FIELD OBSERVATION REPORT

East Hardin Middle School, Hardin County Schools, Elizabethtown, KY 201752.01 -CA8

Report No: 24

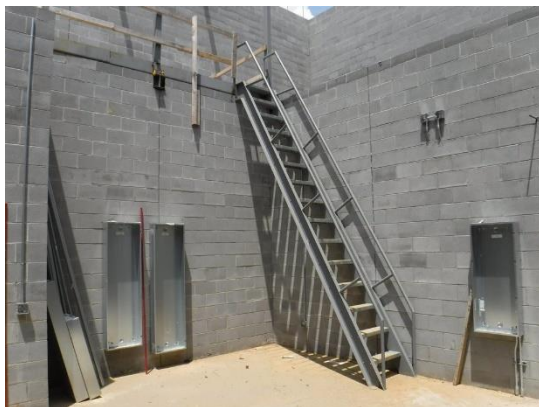
- v) Steel bar joists and metal roof decking has been installed over the Cafeteria.
